CONSERVATION TEAM CONSULTATION APPLICATION RESPONSE

APPLICATION REF:	25/02291/FPH & 25/02292/LBC
CASE OFFICER:	VW
APPLICATION SITE:	Glebe Cottage, Church Lane, Weston, Hitchin Hertfordshire SG4 7DJ
DESCRIPTION OF WORKS:	Single storey rear extension (as amended by plan received on 09/10/2025). Single storey rear extension and internal alterations (as amended by plan received on 09/10/2025).

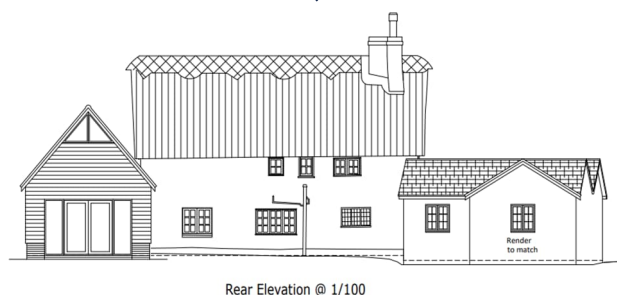
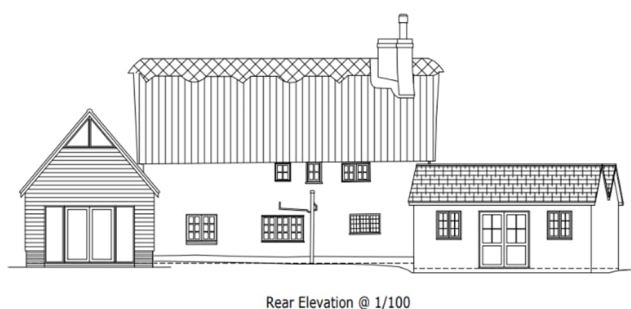
Prior to the implementation of the 2021 consented scheme, the cottage had two first-floor bedrooms with a kitchen located in the slate roof addition at the northern end of the cottage. The 2021 scheme allowed for the enlargement of the northern addition to facilitate two ground-floor bedrooms whilst at first floor the two bedrooms remained. The property was a 2-bed and is now a 4-bed.

I note the justification for the proposal and concur with 4.3 above.

In terms of the roof, I would be seeking natural slate only (handmade tiles adjacent to the slate roof may not work as well and the roof pitch will not be conducive to handmade tiles ideally need to be ≥ 40 degrees).

3. The extension shall receive a natural slate finish unless otherwise agreed and approved in writing by the Local Planning Authority.

4. The rear gable window shall either be salvaged from the existing bedroom extension and reused in the extension's rear gable end or a new window shall be installed that precisely matches the existing window directly to the left on the rear elevation in terms of framing, glazing bar profile, method of opening, ironmongery and external finish.
